**WARREN WOOD RETAINING WALL
MARPLE ROAD A626
STOCKPORT**

RETAINING WALL DESIGN REVIEW REPORT

DOC REF: 294663-WCL-XX-XX-RP-C-0001

View looking down gap between sheet piles and RC wall, January 2023

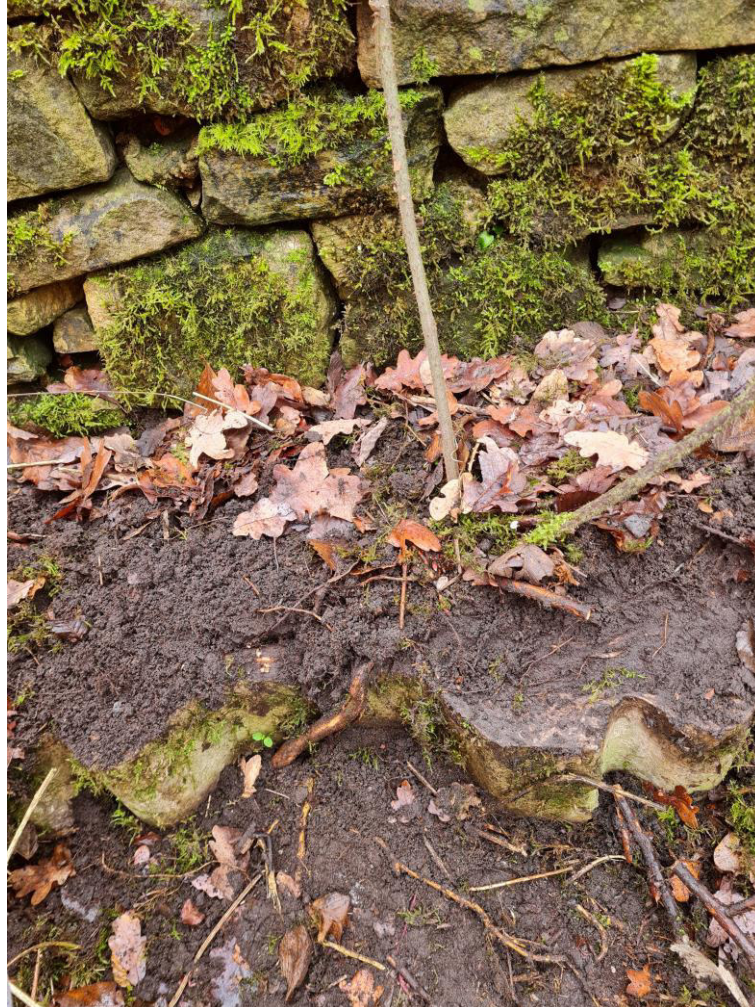
- 6.3 The “back sheets” can be clearly seen on site (see photo on following page). The back face of the RC wall has the same profile as the sheet piles, suggesting that the concrete was cast directly against the piles.

Note: Profile of concrete matches profile of sheet pile, no evidence of back of wall drainage

- 6.4 There was no evidence of any back of wall drainage visible within the gap between the sheet piles and RC wall. Casting the concrete wall directly against the sheet piles would have prohibited the installation of any drainage to the rear of the wall. It is suspected that this drainage element was not installed in accordance with the design drawings. Hydrostatic pressures acting on the back of the wall are therefore considered to be a possible load case, assuming that the loads acting on the temporary sheet piles are transferred directly to the back of the RC wall.

Approximate cross-section through existing wall based on site measurements

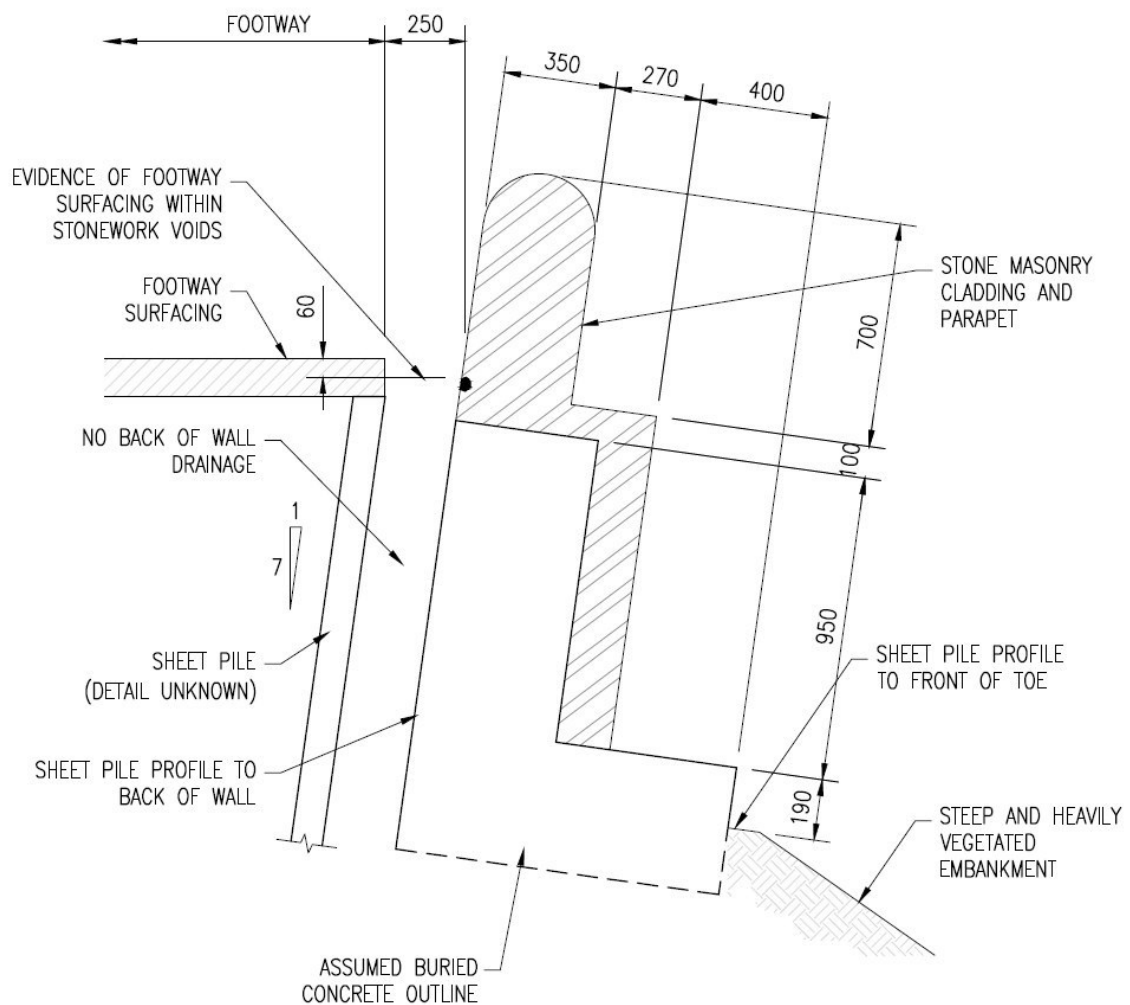
6.6 Based on measurements taken on site, an approximate typical cross-section through the wall in its existing condition can be seen below. The following approximate wall movements were recorded during the site visit:

- Vertical movement: ~60mm downwards.
- Horizontal movement: ~250mm away from footway.
- Verticality: ~ 1 horizontal to 7 vertical (8° from the vertical) leaning away from footway.

- 6.7 The air void between the sheet piles and RC wall suggests that the sheet piles are providing support to the footway and any associated live loads / hydrostatic loads. The sheet piles appear to be out of plumb, which may be due to the following:

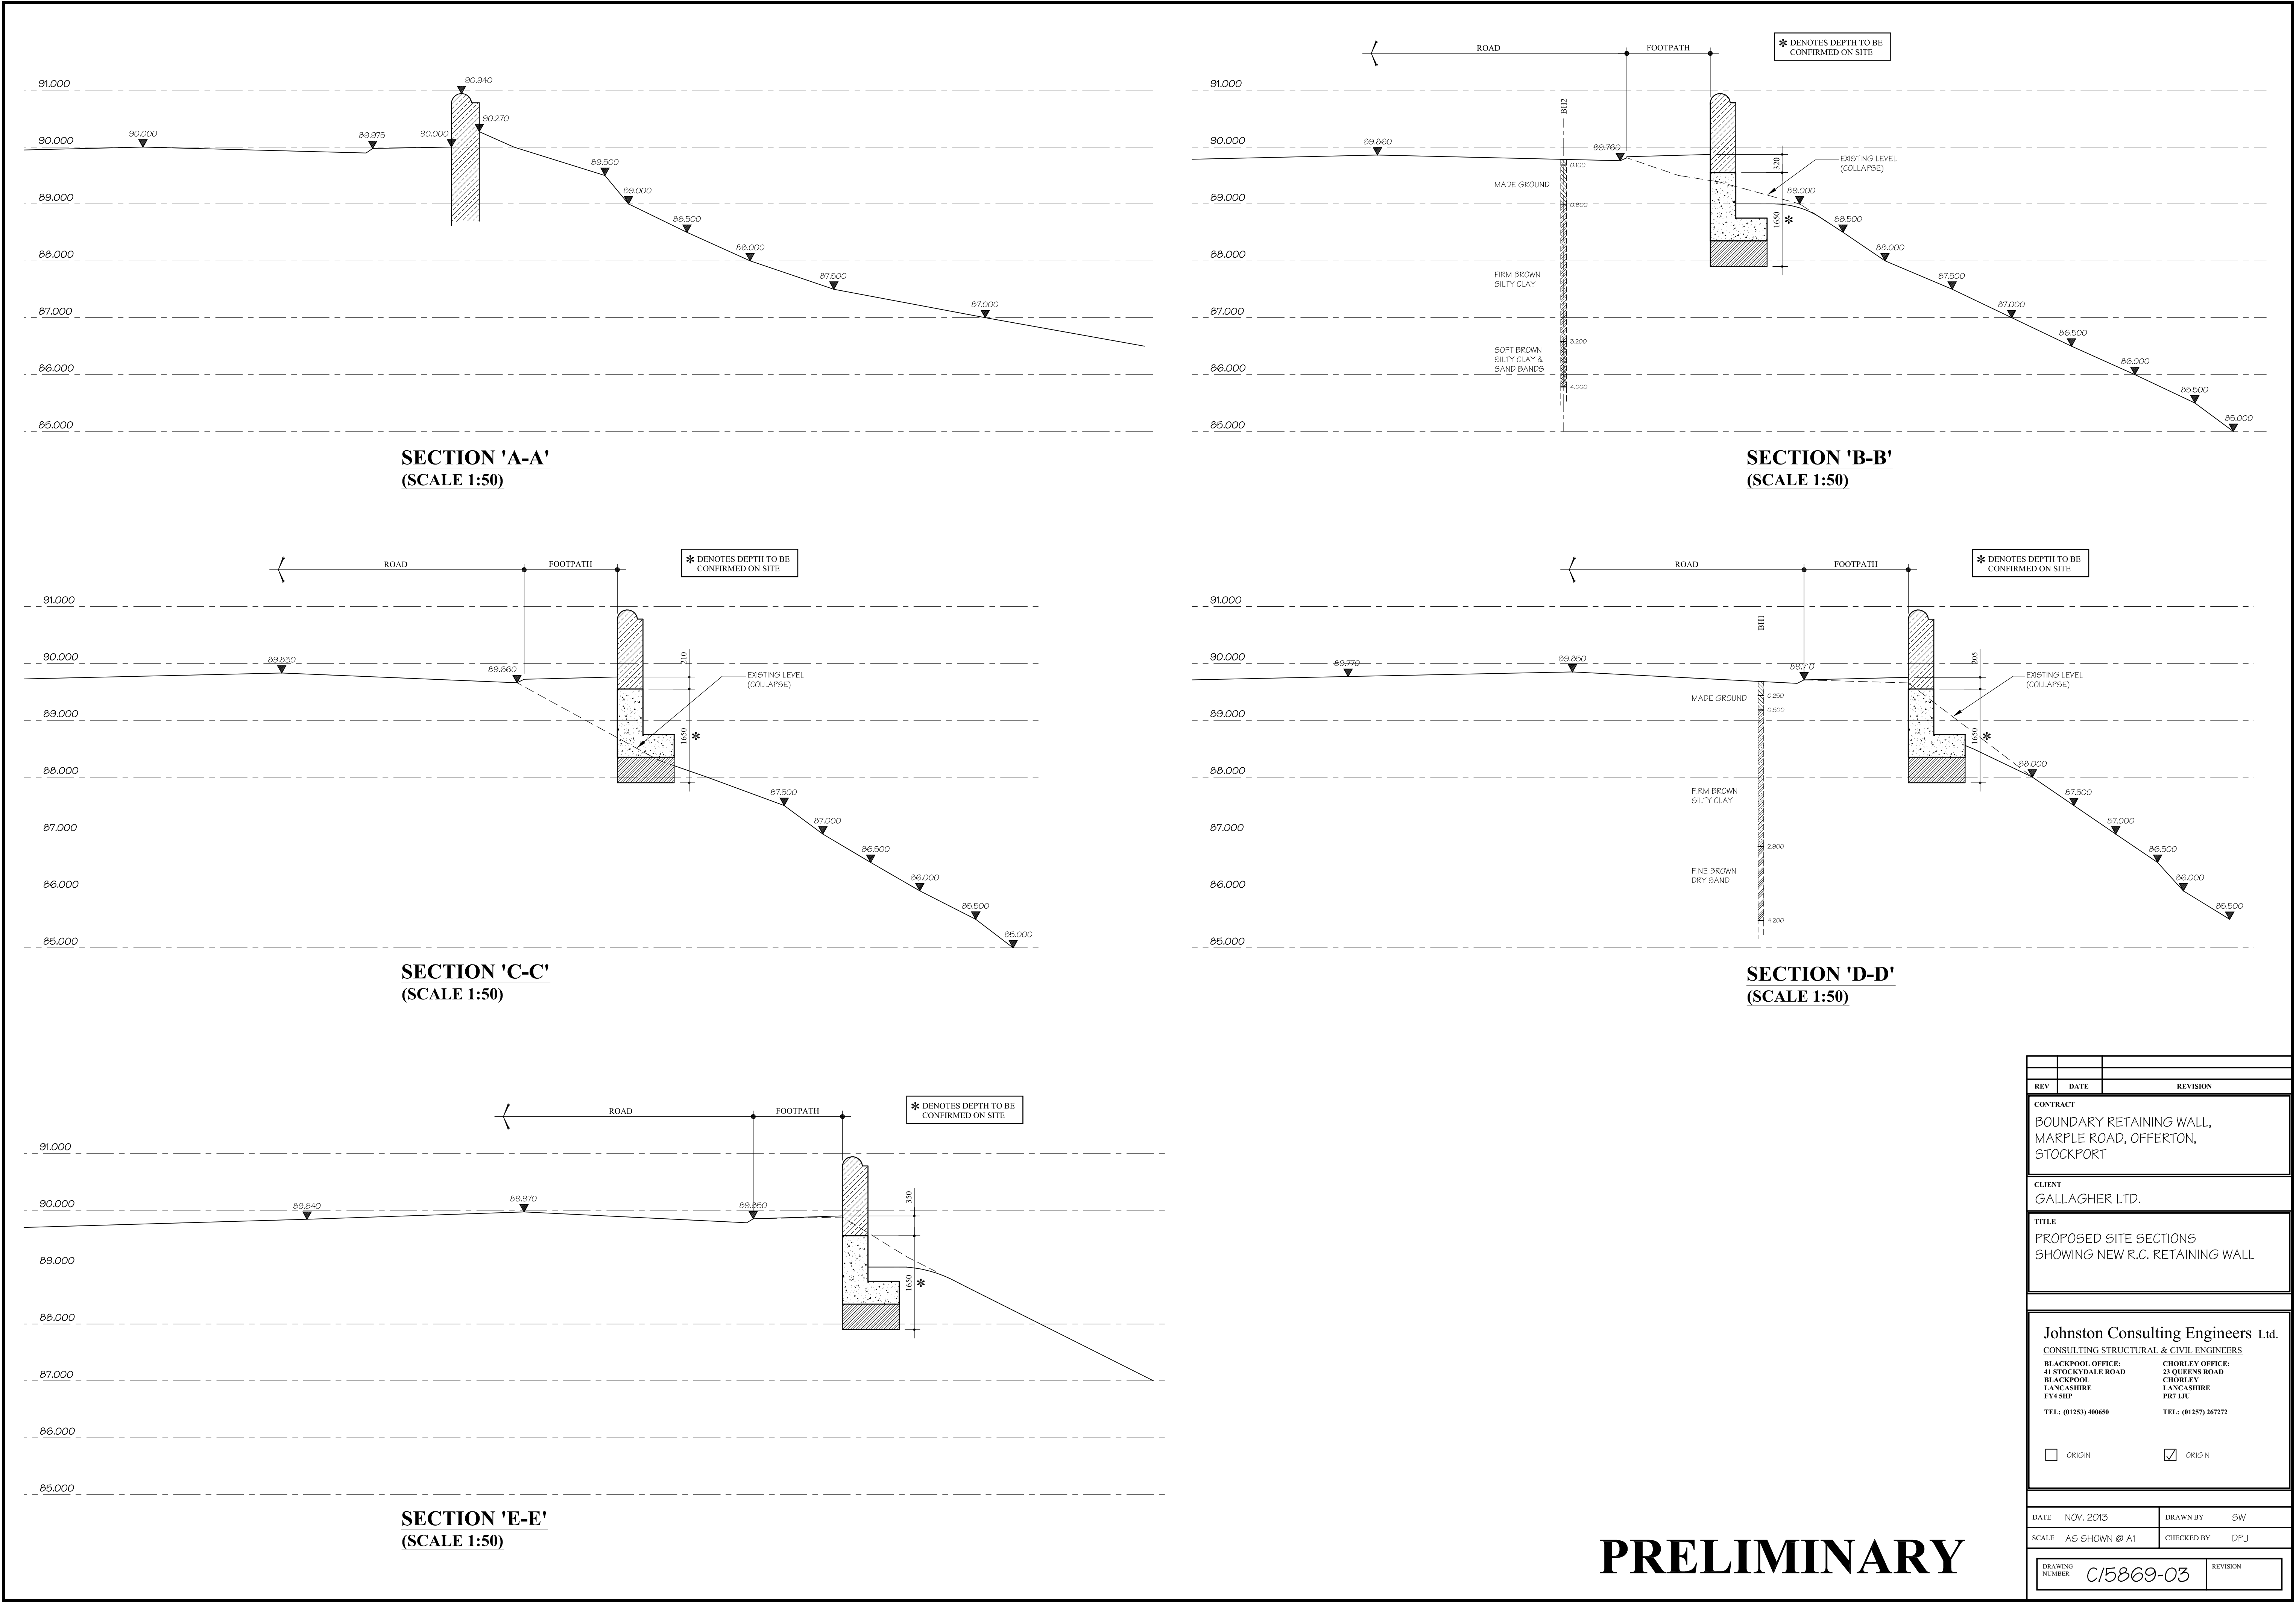
- 6.9 The stone masonry parapet was measured as being approximately 800mm above top of concrete wall level and 350mm thick. This is not what is indicated on the scheme drawings, drawing C/5869-02 shows a minimum height of 1450mm above top of concrete wall level and a thickness of 450mm.

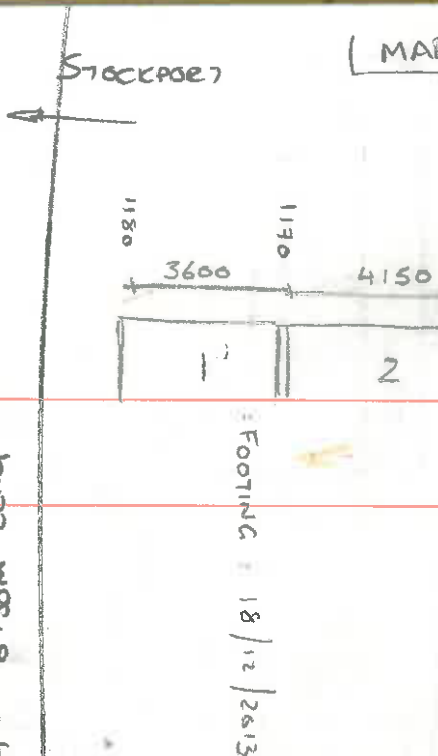
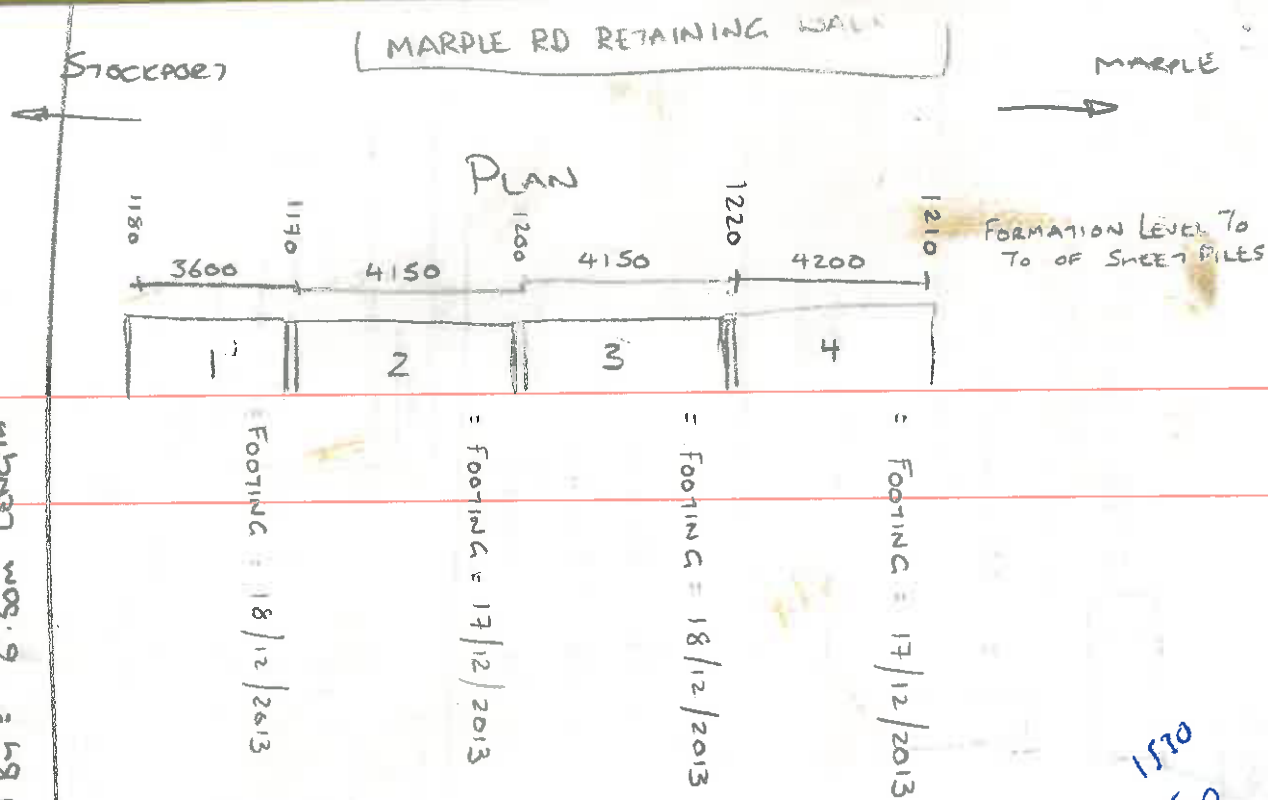
- 5.3 The site notes also refer to 4no concrete bays of length 3.60m, 4.15m, 4.15m and 4.20m for a total wall length of 16.10m. It is noted that this is different to what is shown on the available scheme drawings, which indicate 5no bays for a total wall length of 22.52m.

- 5.4 The reason for not constructing the full length of the wall is not known, however, there is a note on the site notes that reads "Mawsons boss instructed not to go full extent and stop short of double manhole. Short by 6.30m length", suggesting that there was a reason for not constructing the full length of the wall.
